City of Ramsey
Agenda
Special Planning Commission
Monday, June 12, 2017
7:30 pm
Council Chambers, 7550 Sunwood Drive NW

Review Sketch Plan for Cole Addition Sketch Plan (Project No. 17-132); Case of Bryon and Lynn Cole

DATE	6/9/17	PROJECT ADDRESS	10-32-25-31-0002, 10-32-25-32-0006, 10-32-25-32-0005
PROJECT. TITLE	COLE ADDITION, SKETCH PLAN REVIEW		
ESCROW #			
DEPARTMENT:	Community Development: Planning Division (Zoning Code)		
TECHNICAL REVIEWER:	Name: Alec Henderson, Planning Intern Phone: (763) 576-4314 Email: AHenderson@ci.ramsey.mn.us

We offer the following comments regarding the Sketch Plan submittal for Cole Addition as it relates to the City's Zoning Code. The Sketch plan submittal consists of seven (7) sheets, prepared by LANDFORM dated May 23, 2017.

C3.1

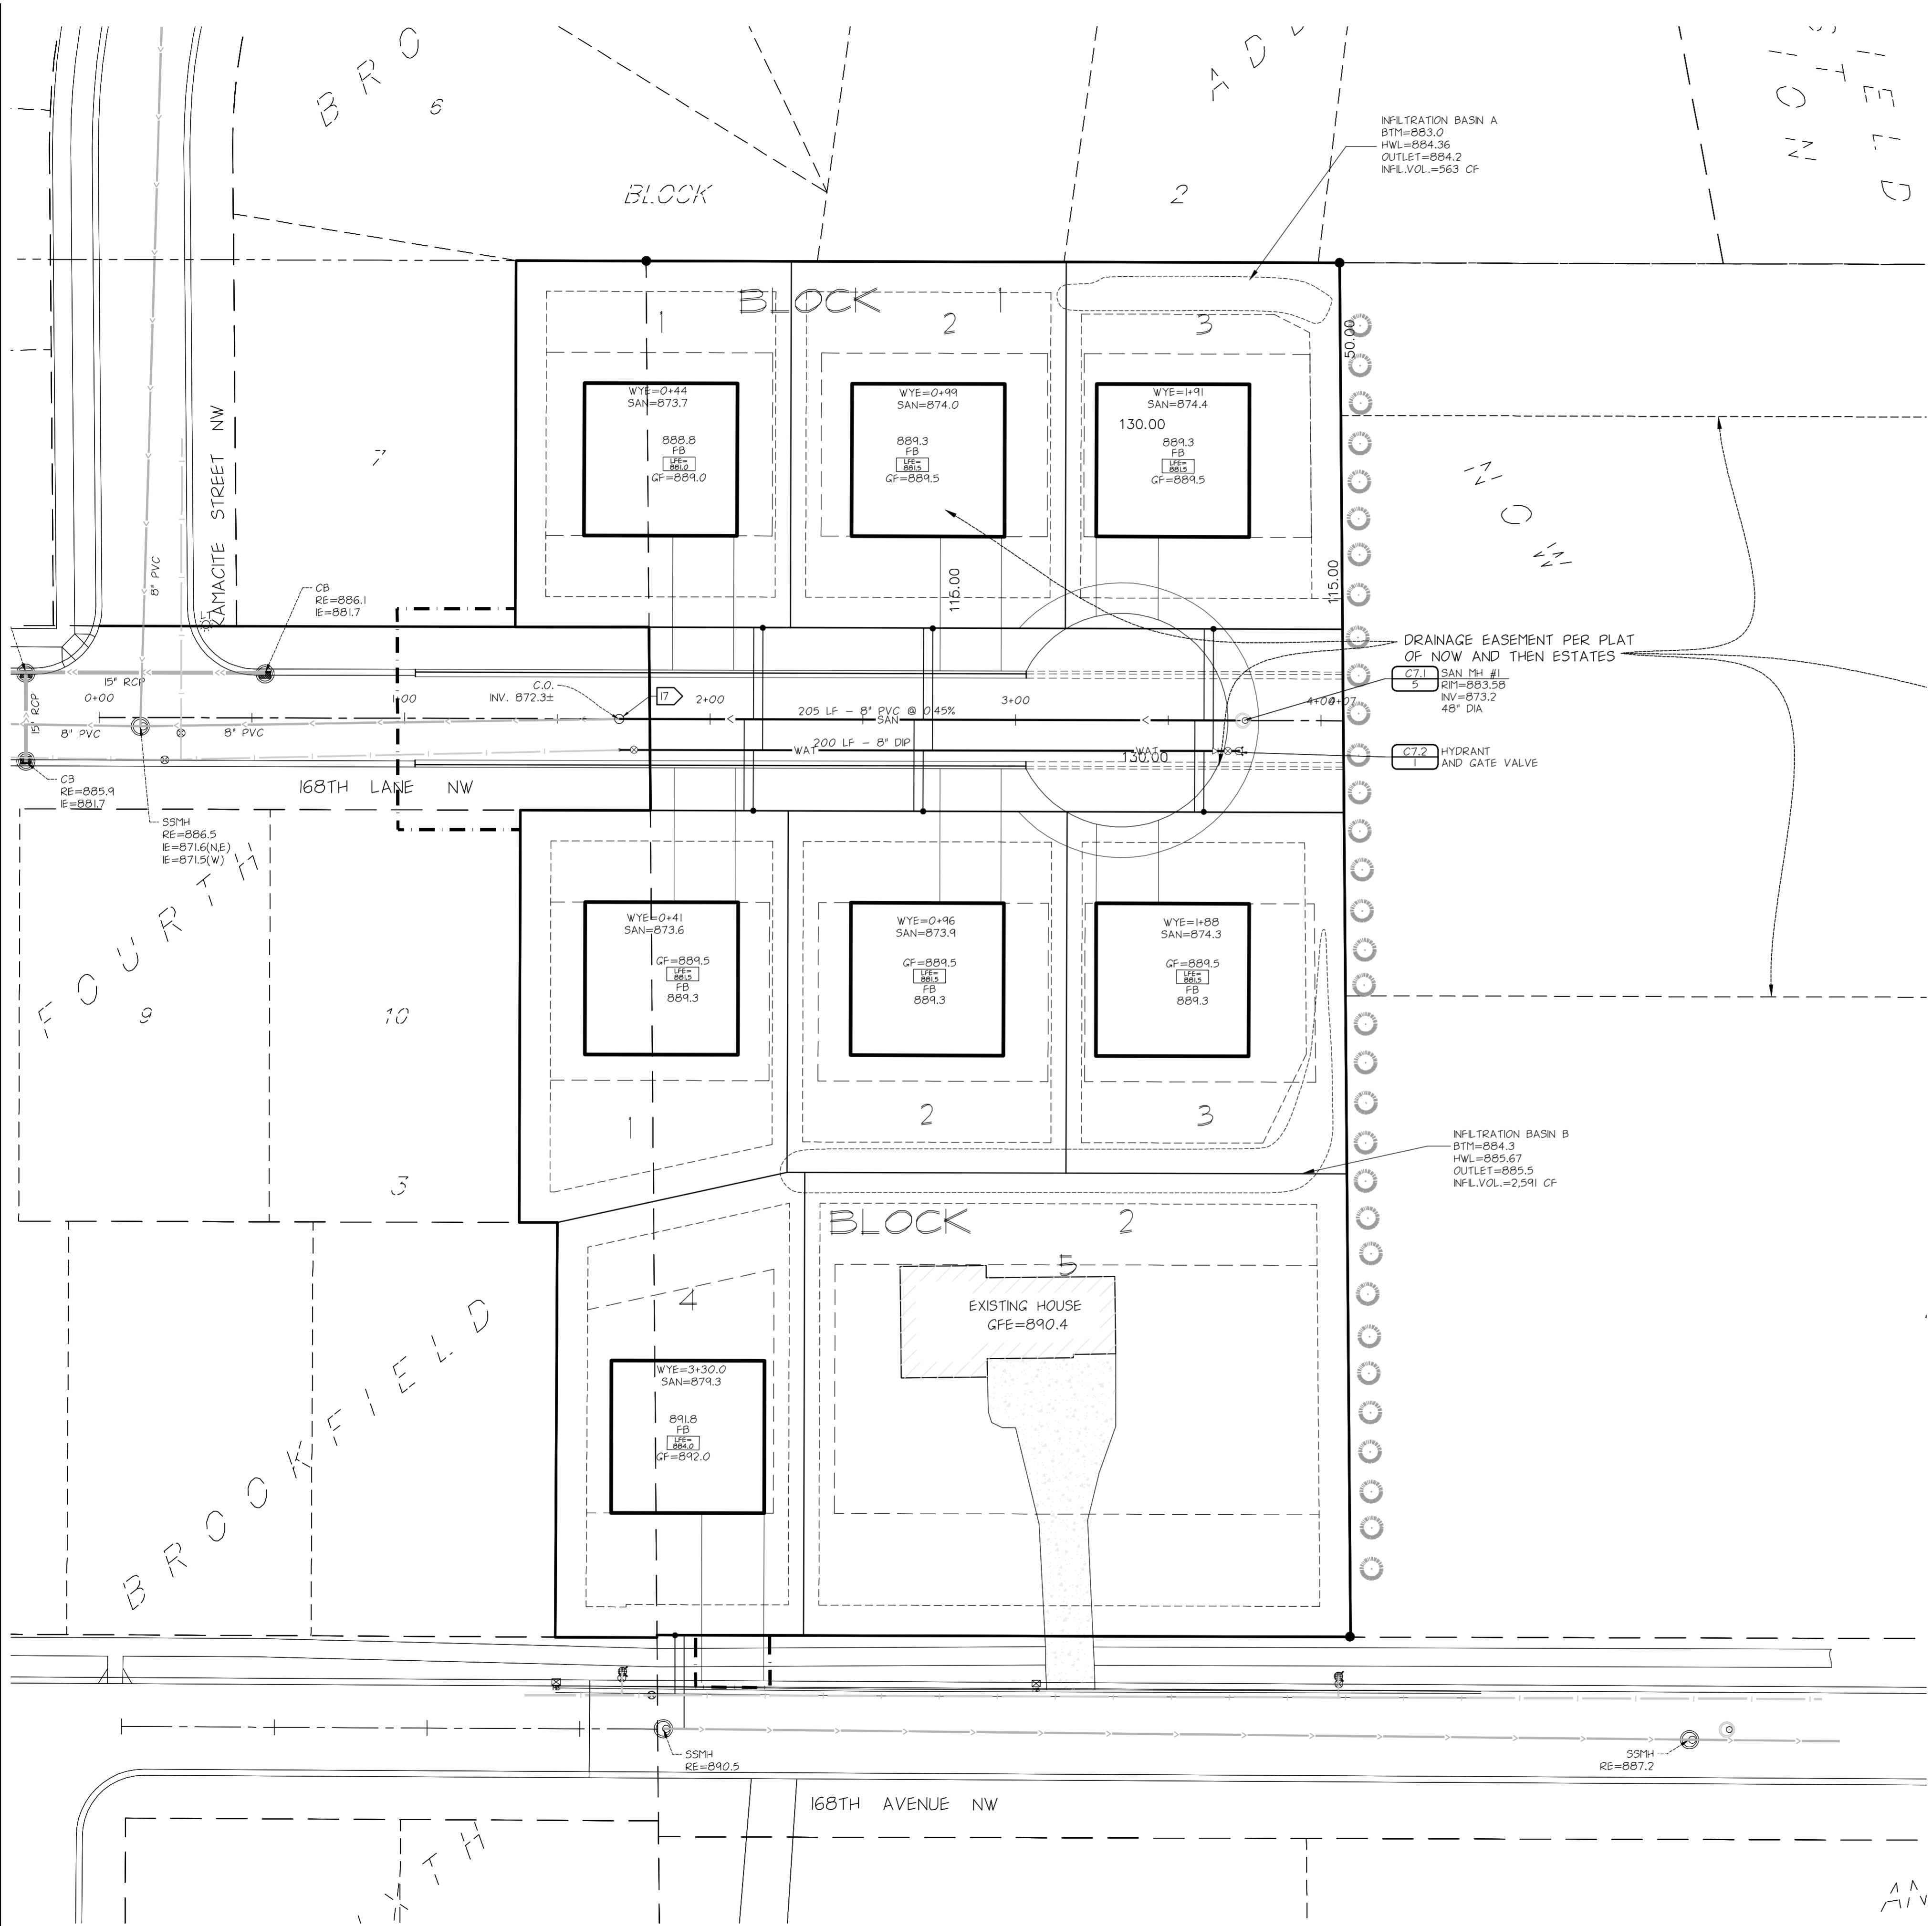
1. Need to show tree save fencing and should differentiate line type from silt fence.
2. North east EOF- no easement, can't run water through there.

C4.1

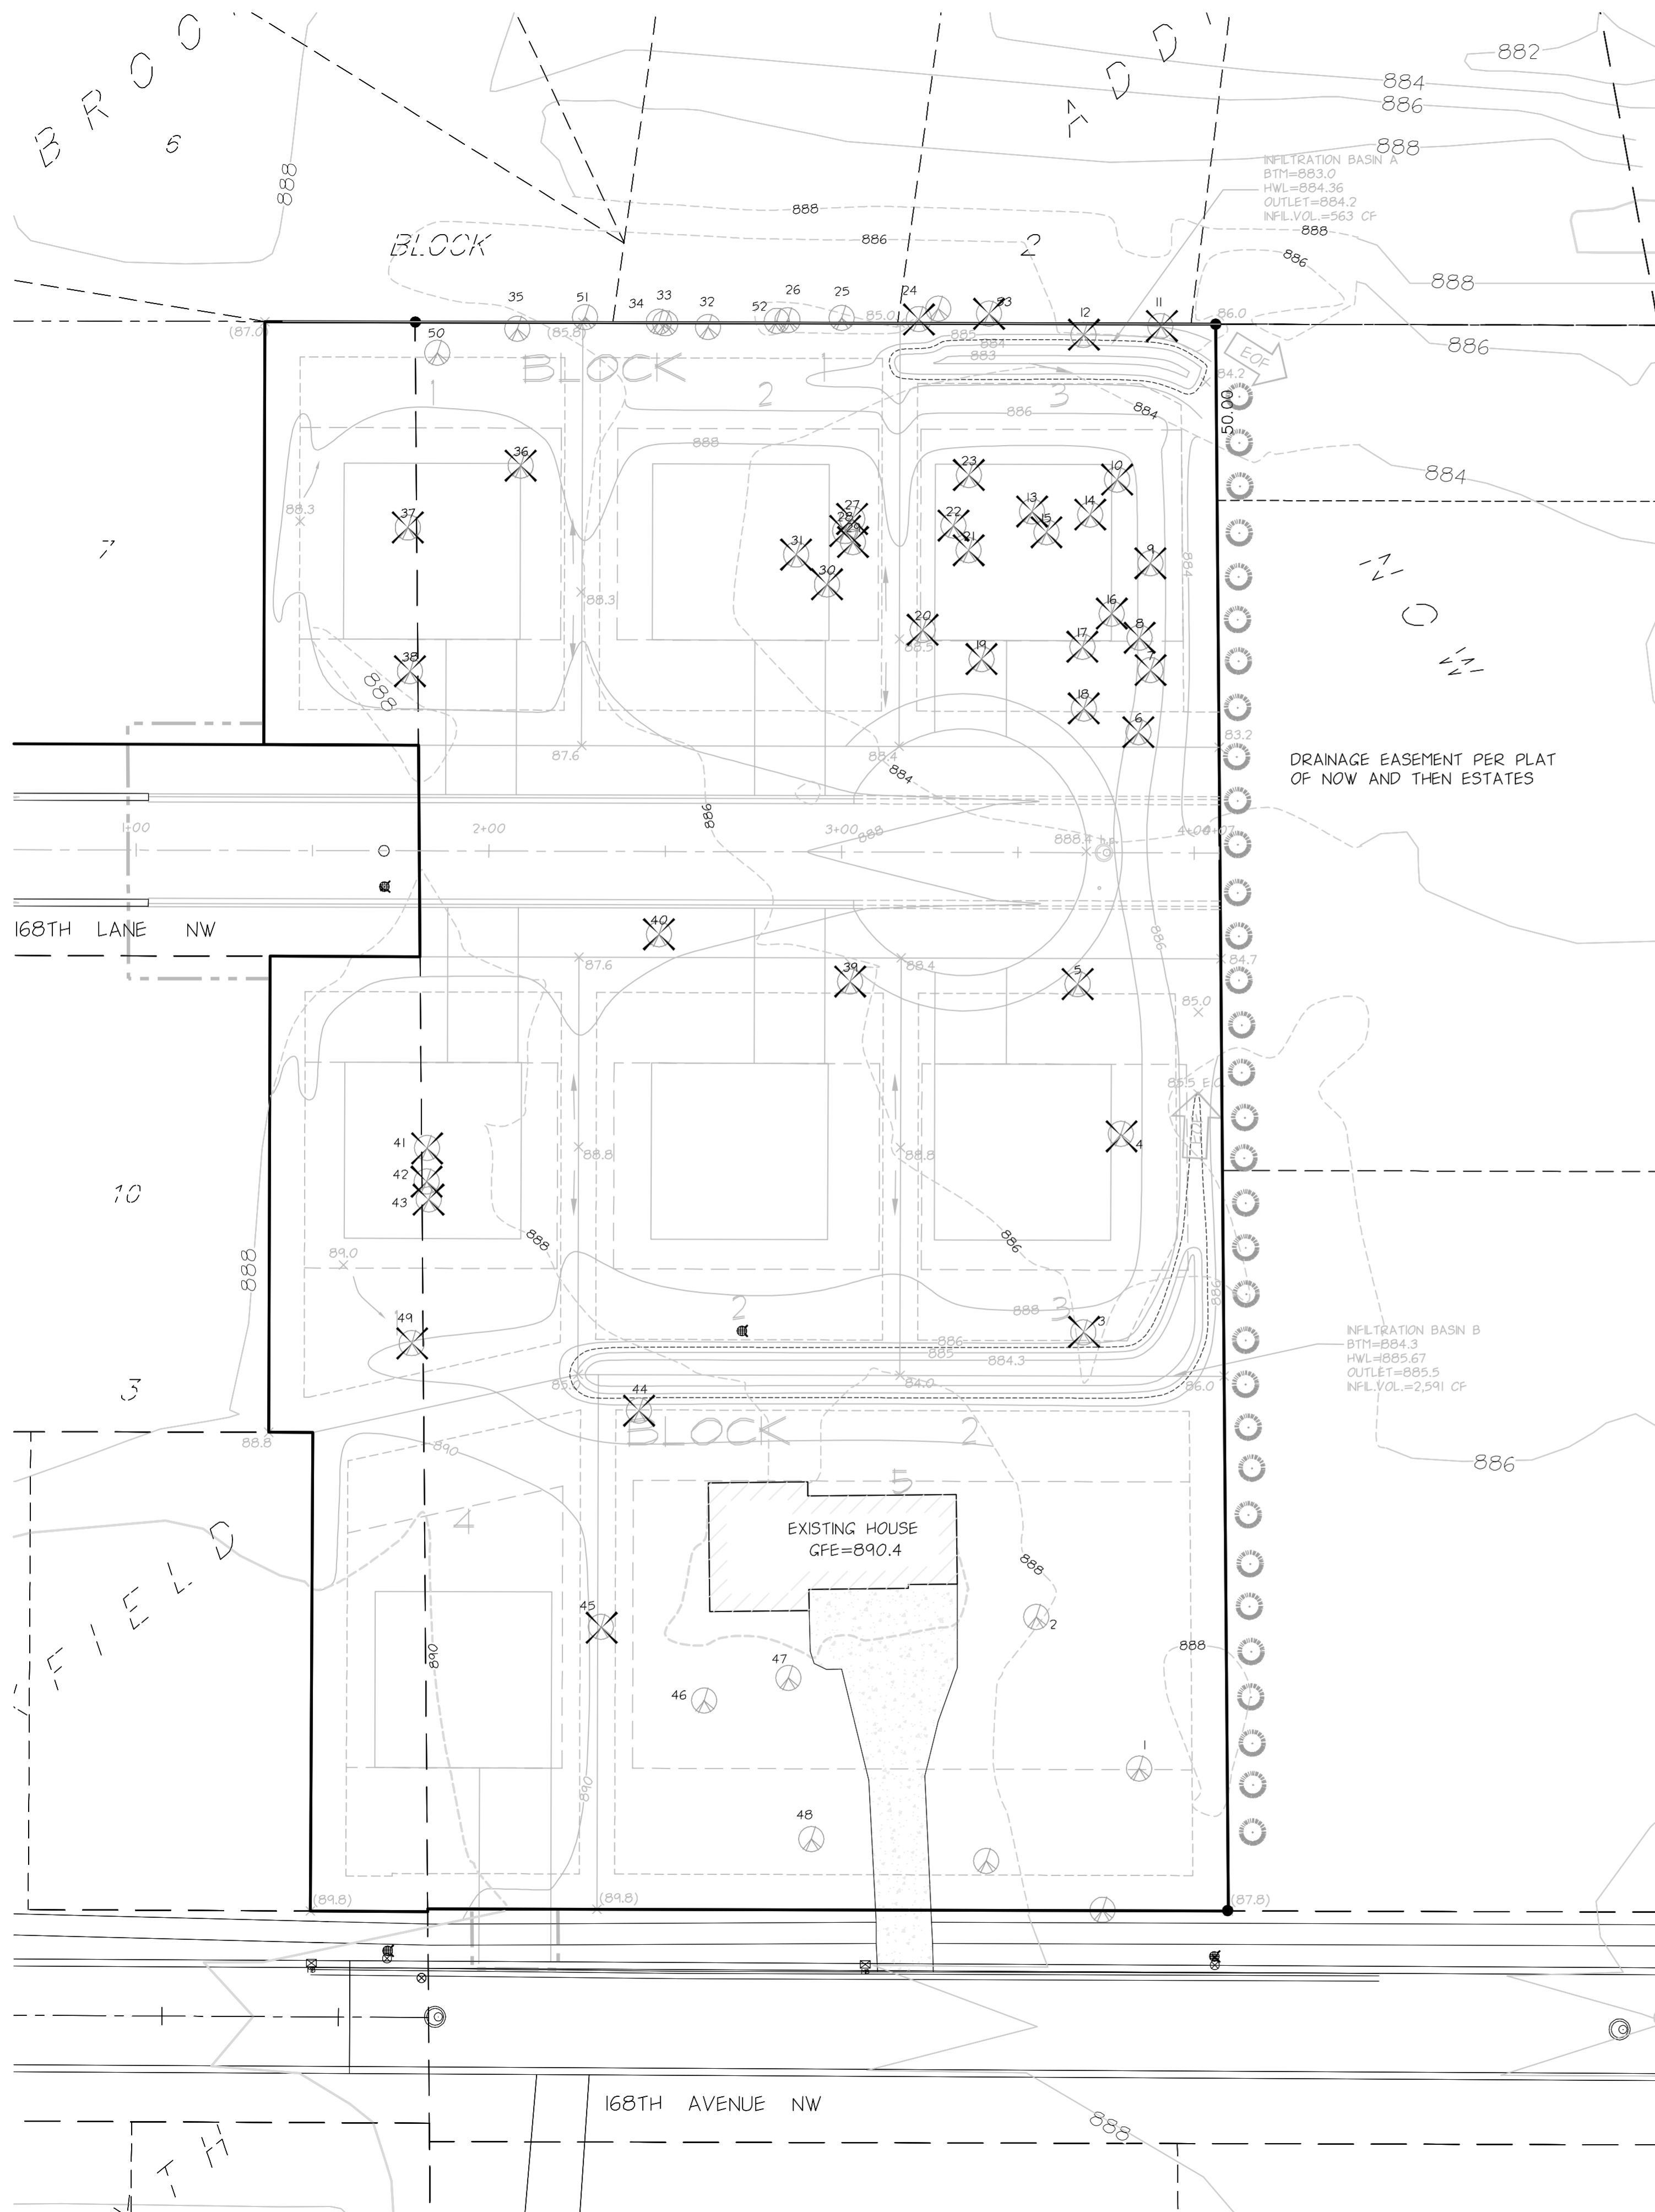
1. Is existing home connected to utilities? Show stubs.

Utilities and Municipal Services: All new lots will be serviced with municipal utilities. The plans must show the existing utility stubs for the existing house and clearly show that the existing home will connect to municipal utilities as part of this project.
